**GULF STATES UTILITIES COMPANY**

February 6, 1985  
RBG- 20,086  
File No. G9.5, G9.23,  
G9.8.6.2

River Bend Station - Unit 1  
Docket No. 50-458

Enclosed are revisions to the River Bend Station Final Safety Analysis Report for your information. Attachment 2 supplements and/or revises my letter of November 29, 1984 (RBG-19,576) on this subject. These revisions support previous discussions with your staff and will be appropriately included in a future FSAR amendment.

Fig. 8.3-14a

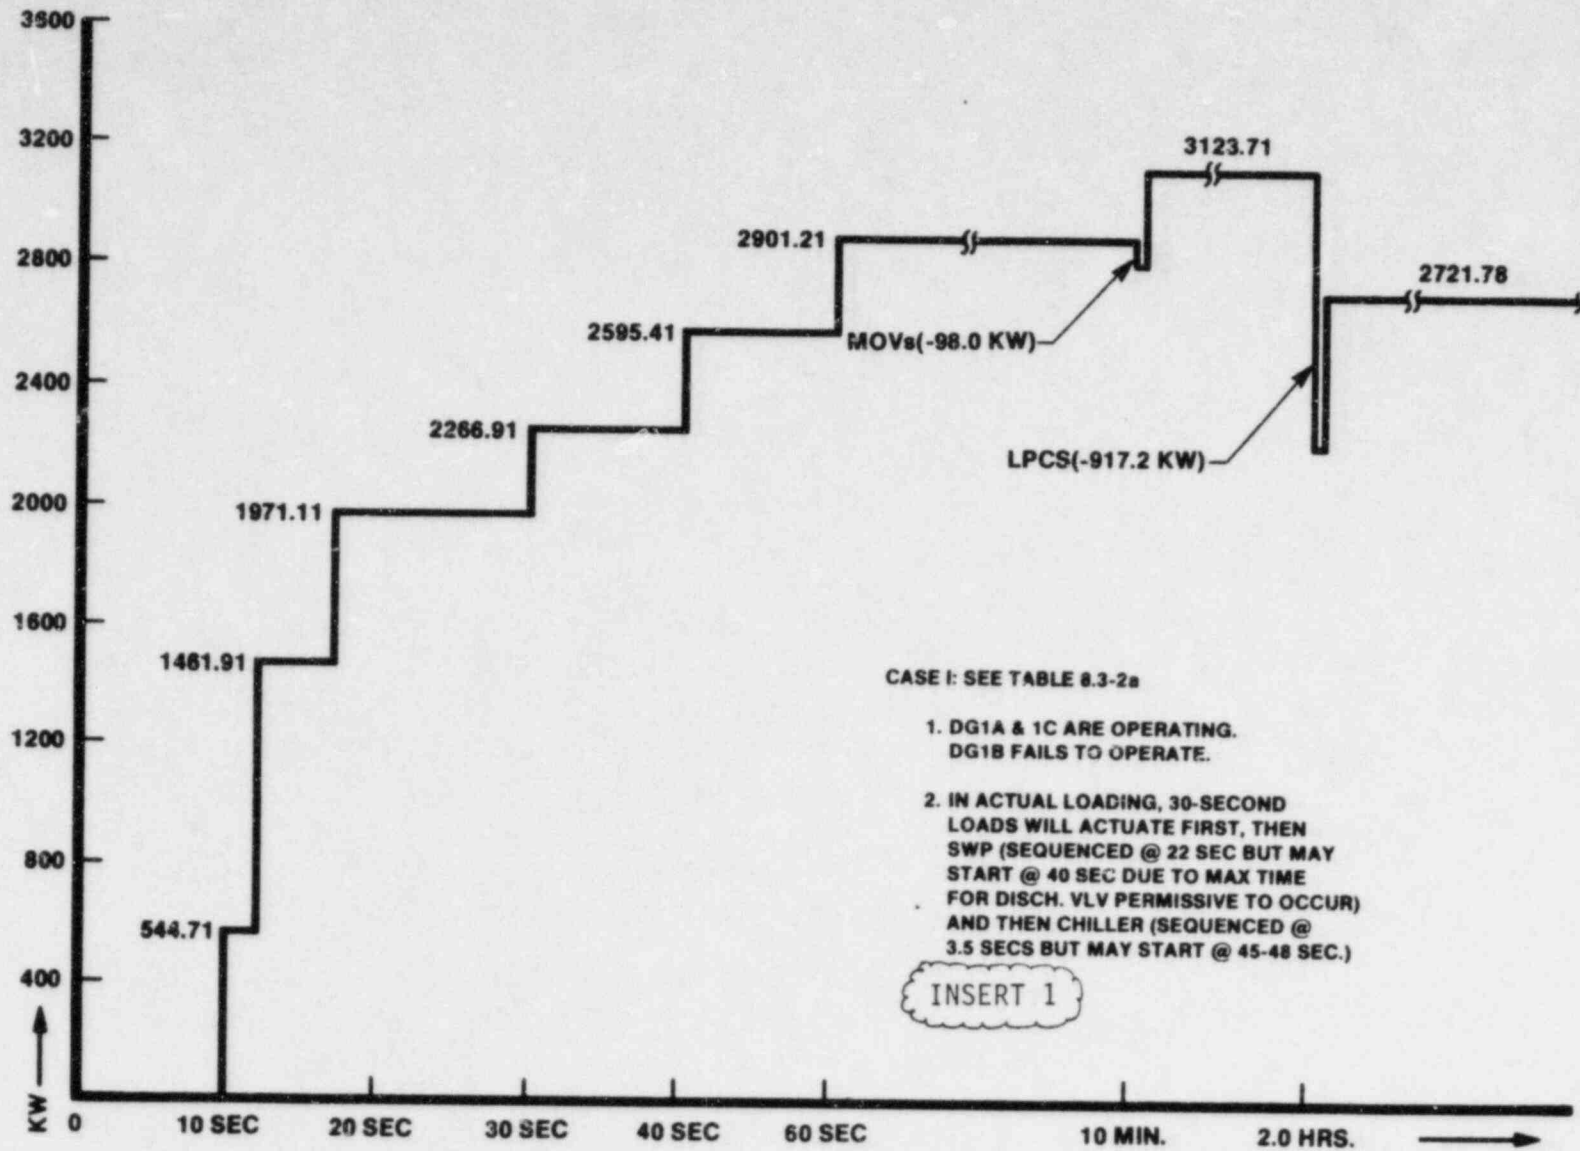
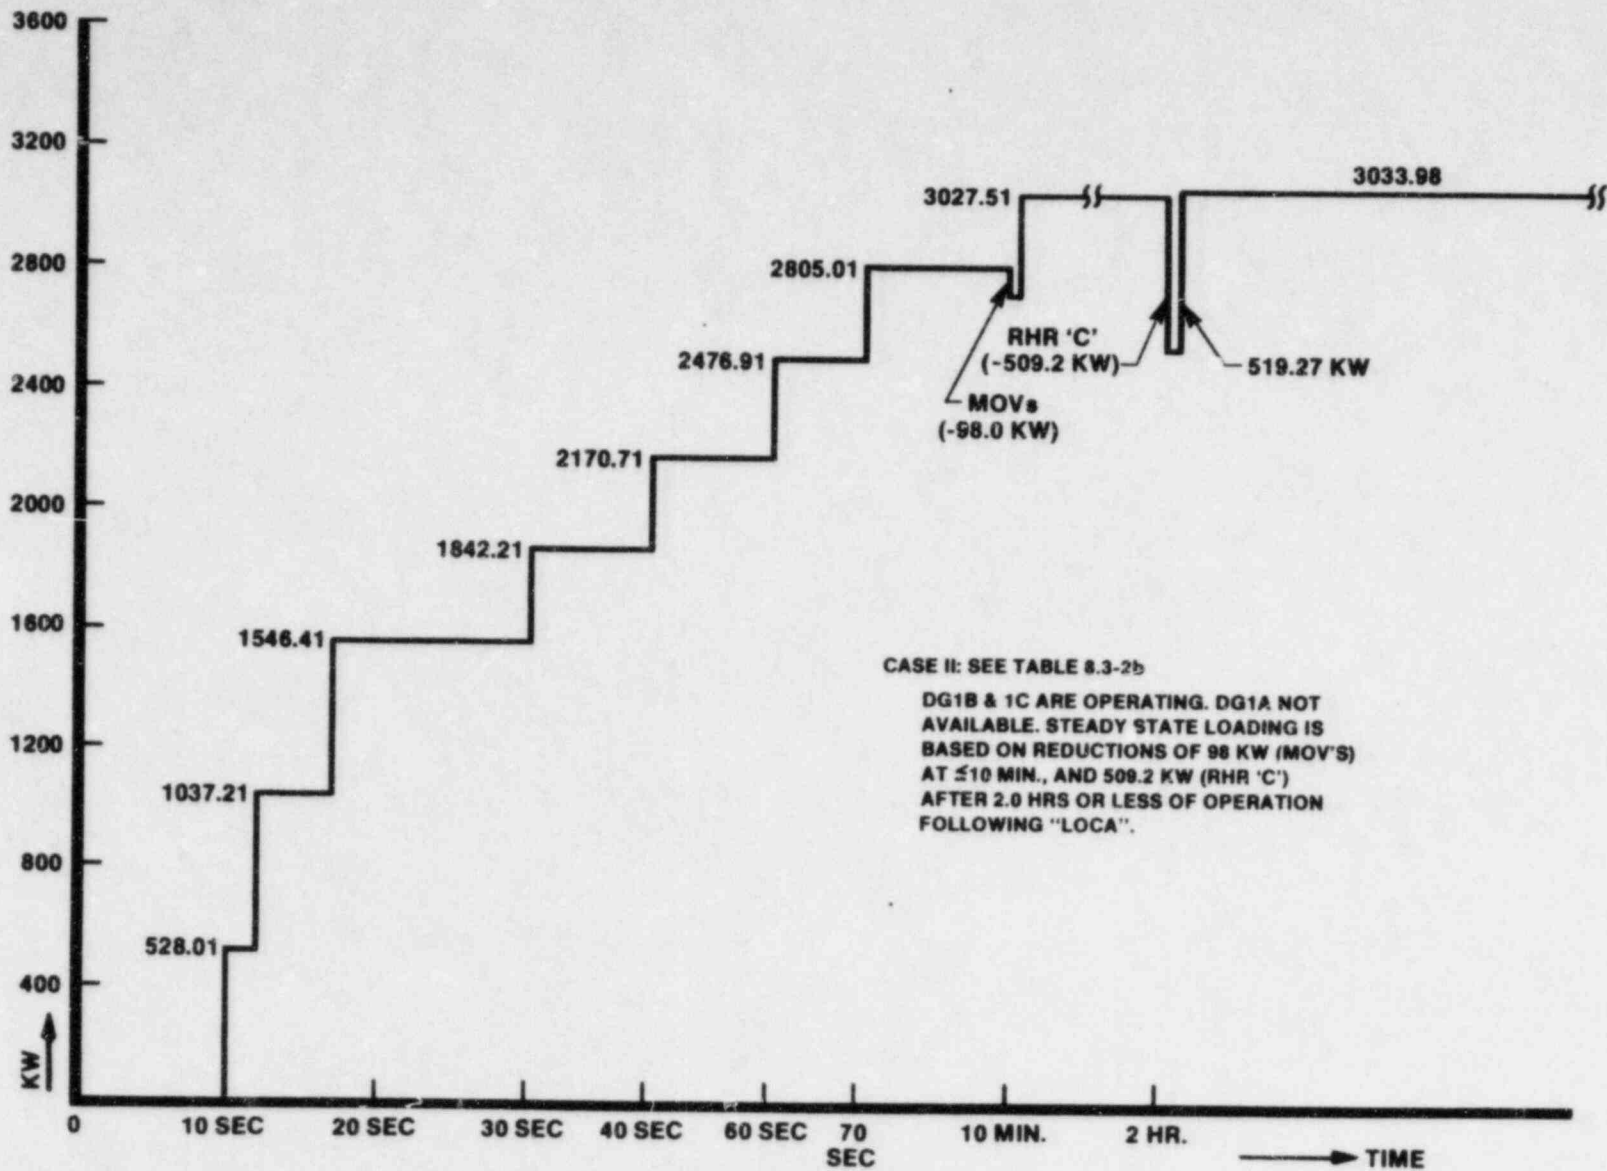
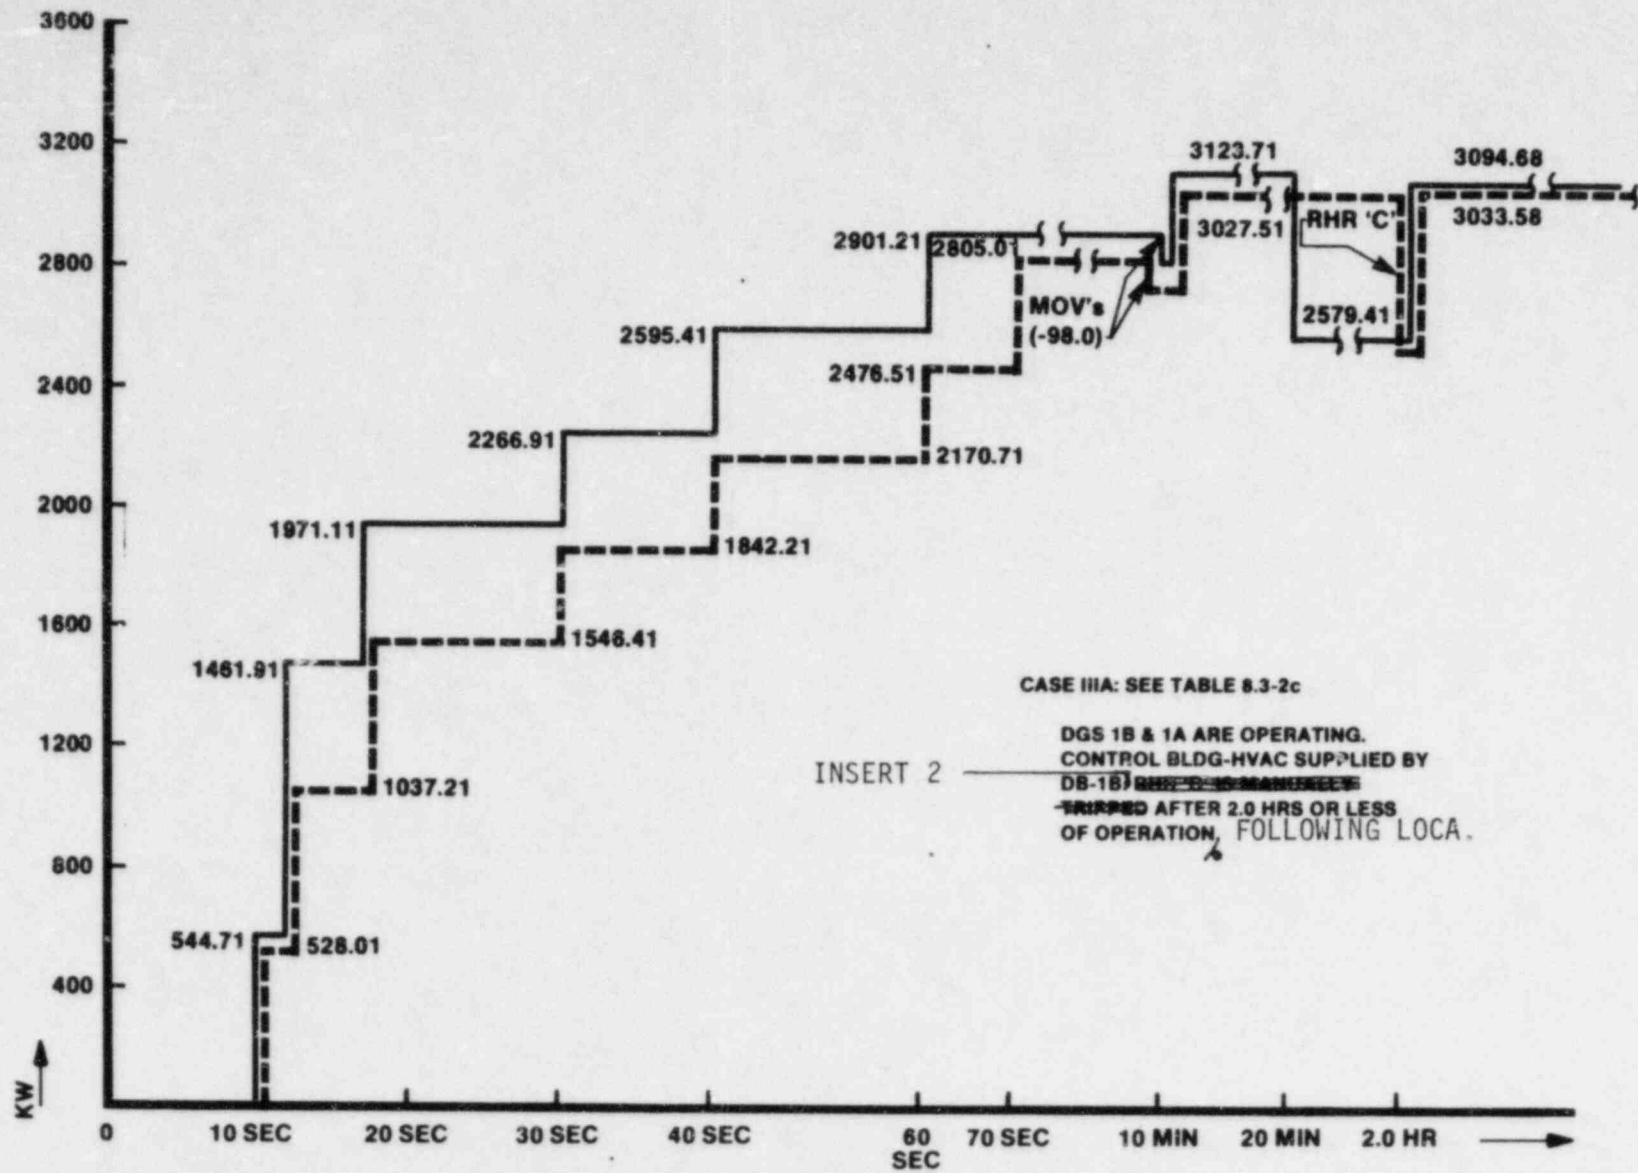
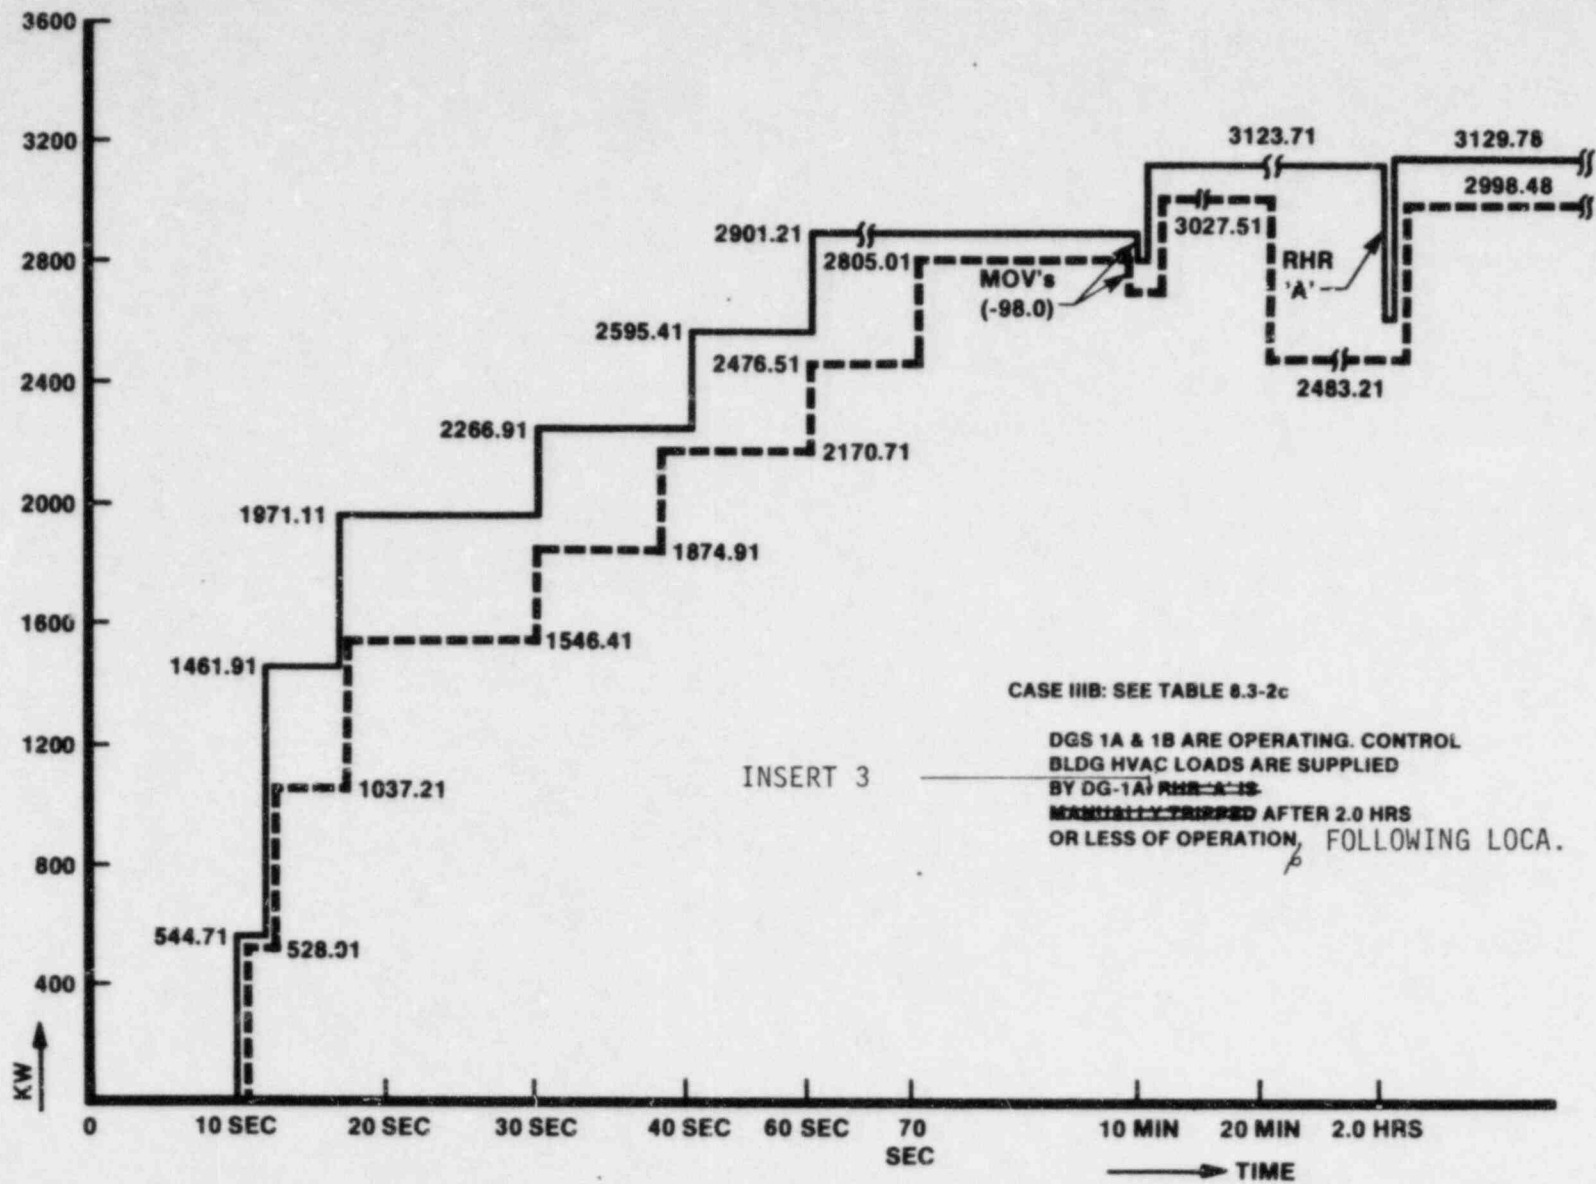
Insert 3

. STEADY STATE LOADING IS BASED ON REDUCTIONS OF 98 KW (MOV<sub>s</sub>) AT 10 MIN AND 509.2 KW (RHR A)
